March 10, 2023

Michael Swidrak, AICP
Urban Planner III, Development Division
Department of Planning and Zoning
Alexandria, VA 22314

Re: DSP#2023-00001 / SUB#2023-00001– Potomac River Generating Station Site
Comment Response Letter to Completeness Compiled Comments for PRGS IDSP

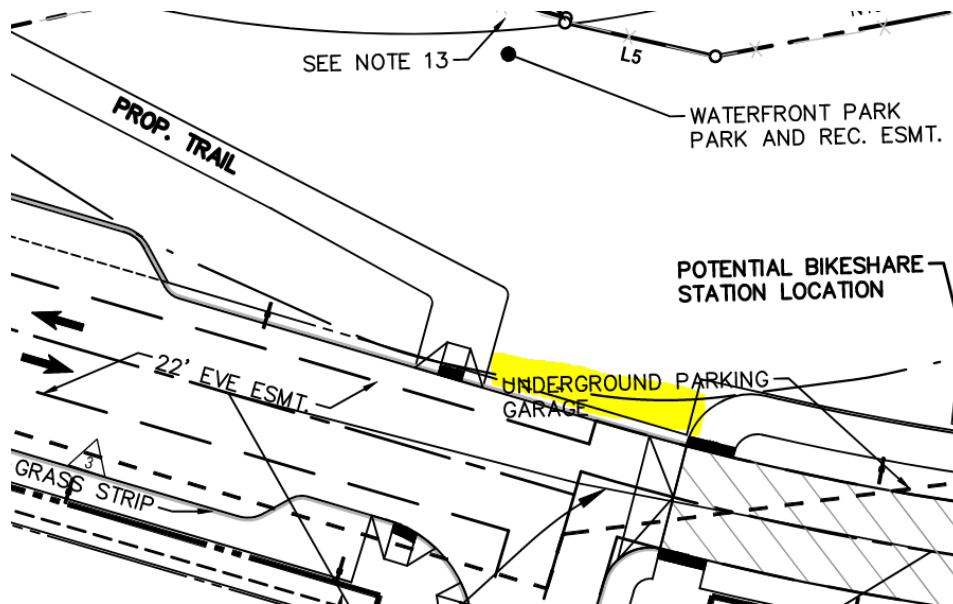
7. The names for private and public streets should be submitted as a single street naming case (SNC) with the former approved administratively and the latter approved by public hearing. The public street name for Road A should be approved prior to release of the IDSP final site plan.
 - a. Staff recommends submitting the SNC case materials for review with the next IDSP submission or soon after in order to allow for staff review time and public approval.

Response: Applicant will submit the street naming case for Road A in accordance with CDD Condition 157, which states approval by Planning Commission must occur prior to the release of the first Final Site Plan, and is not a requirement of the Preliminary Site Plan. (P&Z).

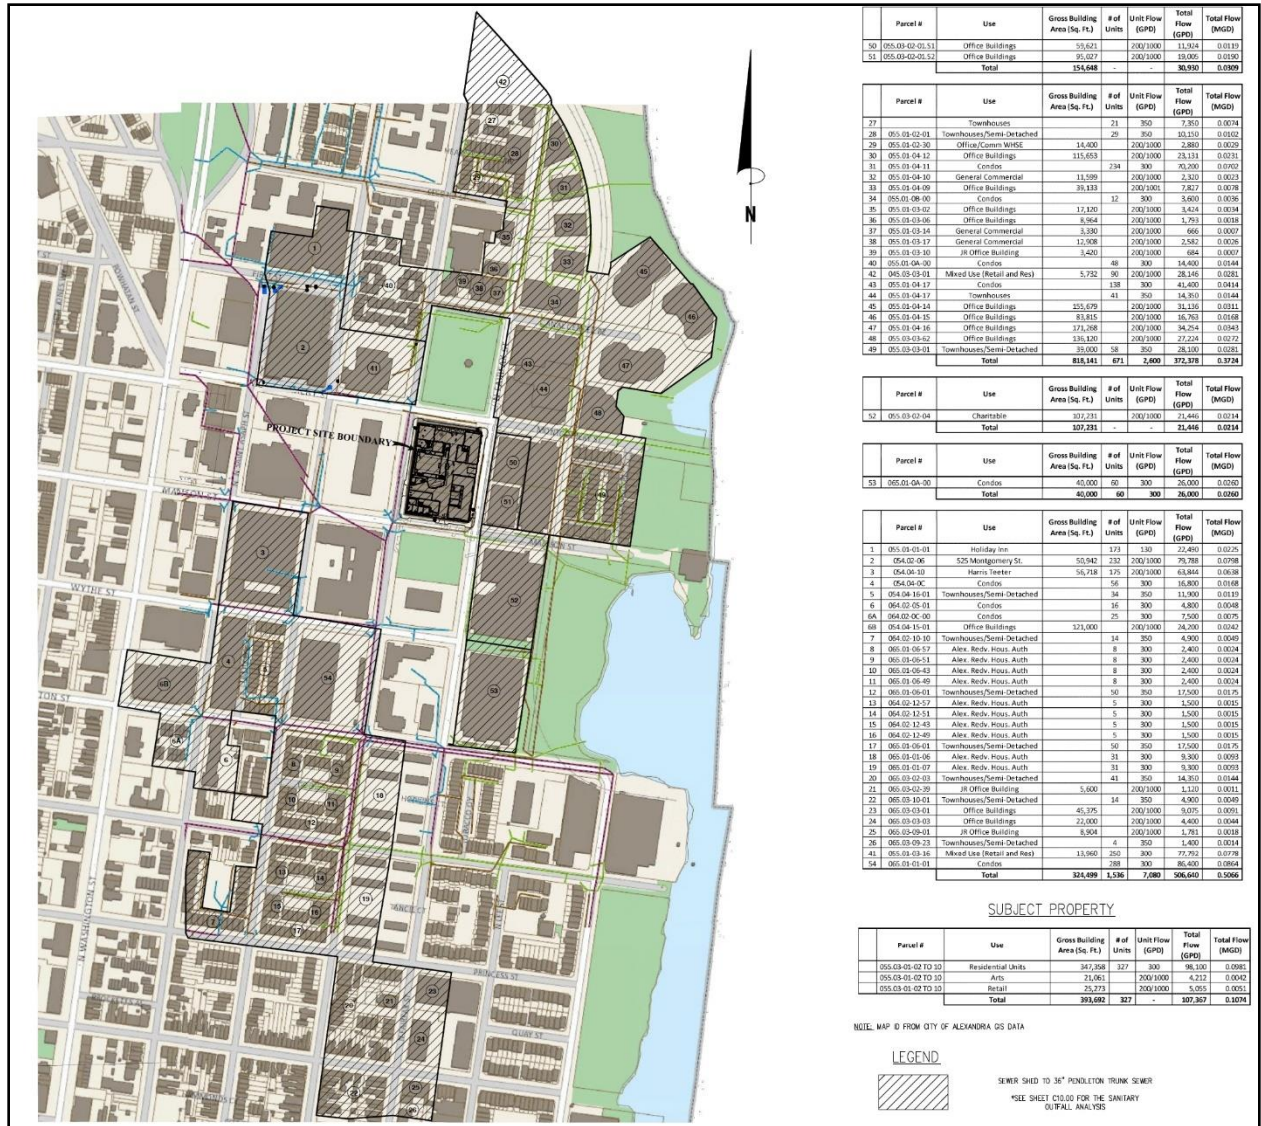
7. Sheet C700 - Clarify where the existing pump house will be tied into the city sewer system as part of the development project. **(Sanitary)**

Response: A note has been added to Sheet C700 to clarify the pump house sanitary connection into city sewer system. See Sheet C700.

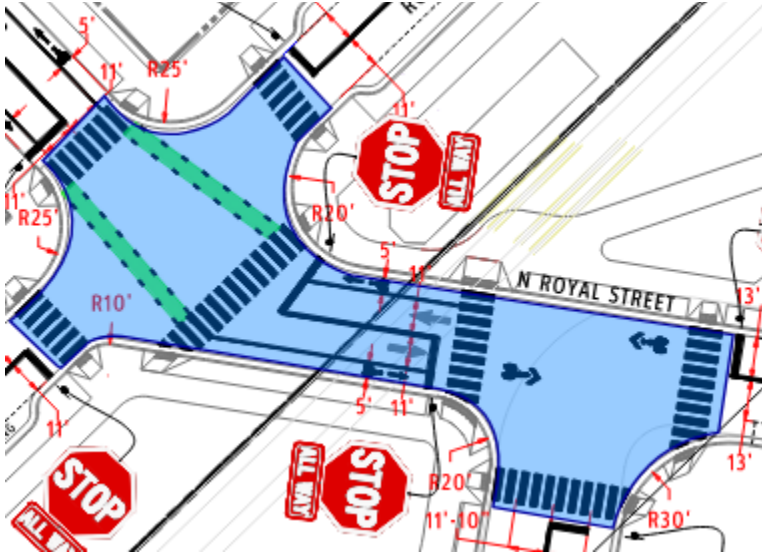
27. For the public access easement on east side of Block B, for Fairfax street: please extend the northern leader to back of proposed walk for clarity, is currently pointing to middle of walk. (Survey)

Response: The northern leader has been revised. See Sheet C303.
